I respectfully submit this narrative along with the revised permit plans in response to your comments regarding the above referenced project.

Action	Comments	By	Date
DN	B1100804 1. Provide Drawings of existing Building. Including :roof and floor framing. Verify if roof framing is designed for a Roof Terrace (LL=100 PSF) or a Roof only (LL= 30 psf) ; indicate what is to be removed and what is to be reinforced 1.1 Provide roof and floor framing plans that are fully dimensioned and to scale 2. New beam over bedroom 109 is not shown on section 1/A08 Is this beam replacing a Bearing wall ??? 3. Design calc.s for w8X18 call for lateral support at 24" but there is no lateral support for 16 ft 3.1 Provide design Calc.s and details for connections of 8X18 and HSS to column and to walls 3.1 check existing foundation for the added loads 4. Provide design Calc.s and details for guard rails 5. Provide design Calc.s and details for framing connections with #10 TEK screws 6. Provide design Calc.s and details for roof diaphragm; Include wind load on parapets per ASCE 7 section 6.15.12.2.4. Use Diaphragm tables per APA, ISANTA or other Approved Agency 6.1 Provide design Calc.s and details for shea

1 SHOWER PAN DETAIL
SCALE: 3" = 1'-0"

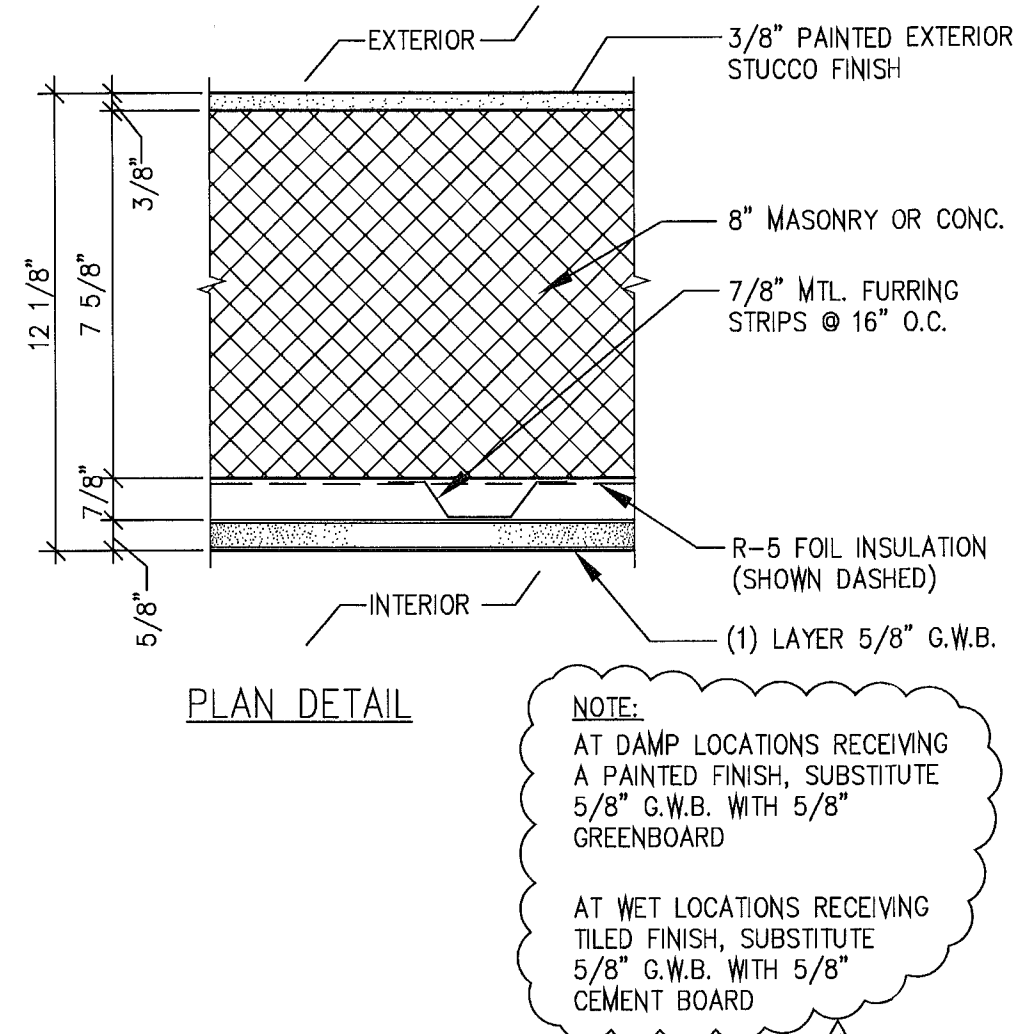
2.) PROVIDE SHOWER DETAIL.

R. ARCHITECT TO PROVIDE SHOWER DETAIL.

For shower pan detail, see detail 1 on architectural sheet A-11 (Do not confuse detail 1 with partition type 1!!)

1ST FLOOR ELECTRICAL PLAN

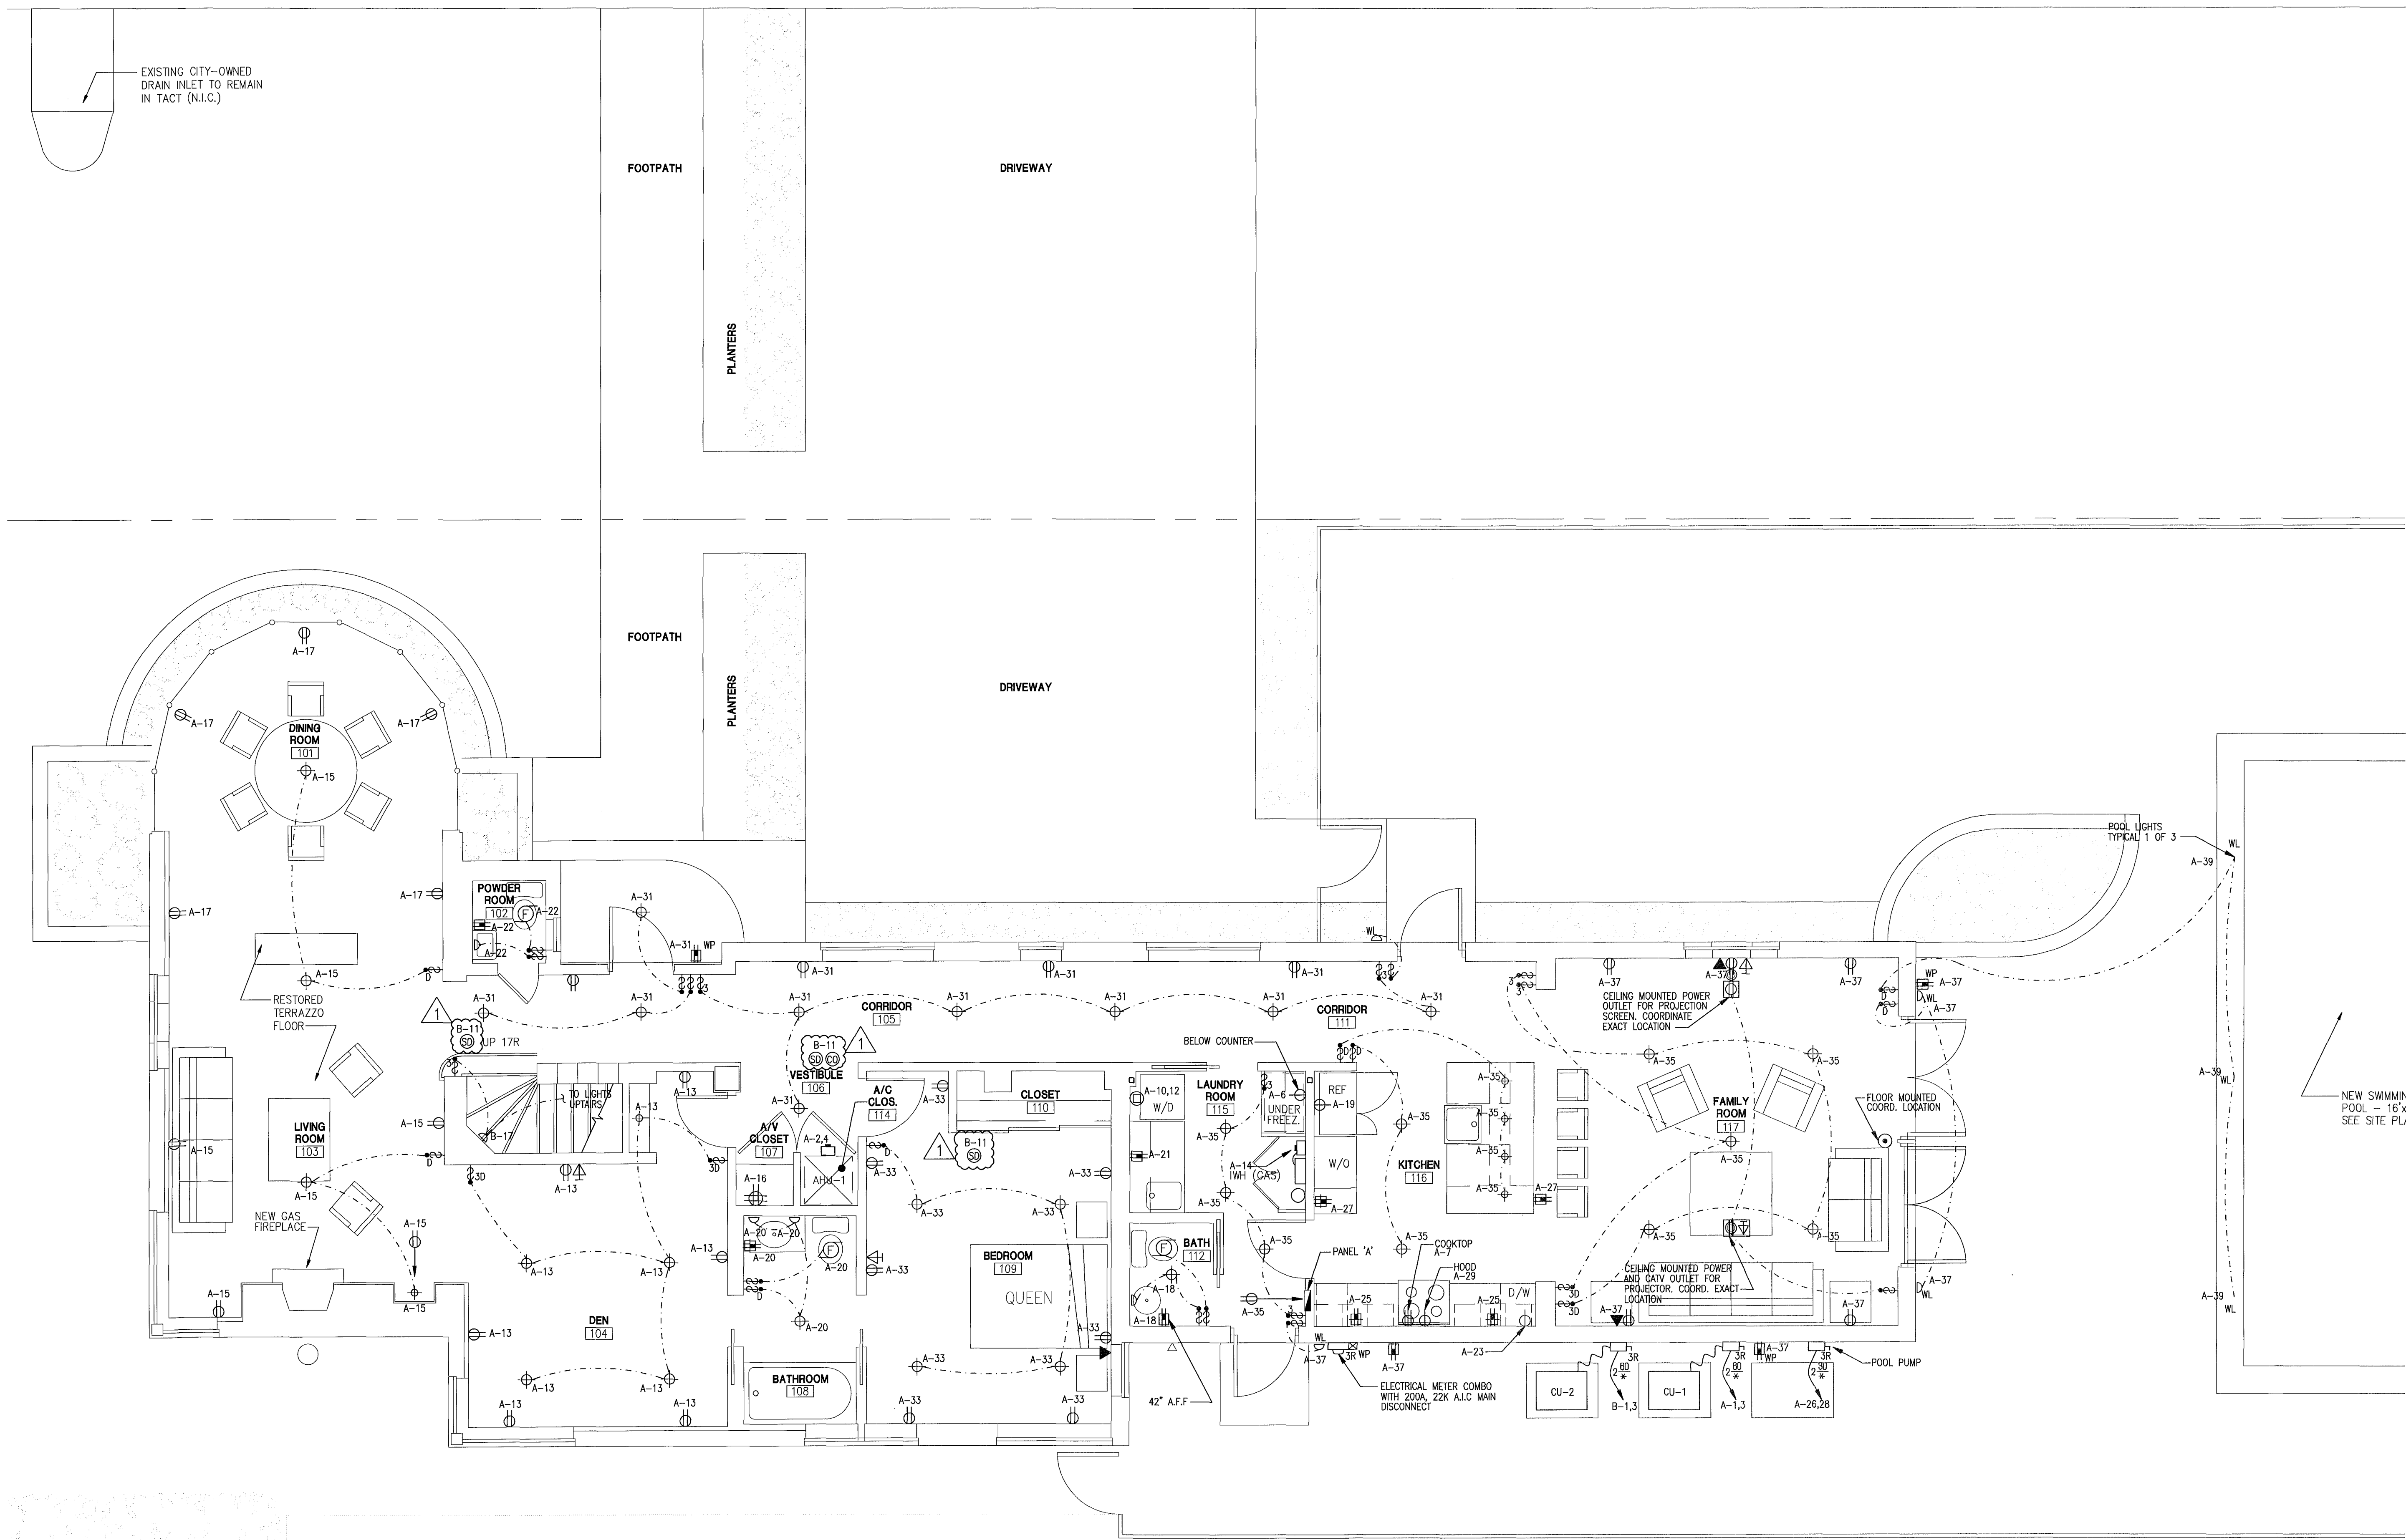
- 1.) MUST PROVIDE CIRCUIT IDENTIFICATION FOR SMOKE DETECTORS.
R. PROVIDED. PLEASE SEE REVISED SHEETS E-1 & E-2.
- 2.) PROVIDE CARBON MONOXIDE PROTECTION FOR 2ND FLOOR BEDROOMS SHALL HAVE AN OPERATIONAL CARBON MONOXIDE ALARM INSTALLED WITHIN 10 FEET OF EACH ROOM USED FOR SLEEPING PURPOSES.
R. PROVIDED. PLEASE SEE REVISED SHEETS E-1 AND E-2.
- 3.) MISSING SMOKE DETECTORS IN BEDROOMS.
R. PROVIDED. PLEASE SEE REVISED SHEETS E-1 & E-2.
- 4.) MISSING GFCI OUTLET IN NORTH SIDE BALCONY.
R. PROVIDED. PLEASE SEE REVISED SHEET E-2.

13.) CO detector has been added to electrical plans - see E-1 (Vestibule 106) and E-2 (Stair landing).
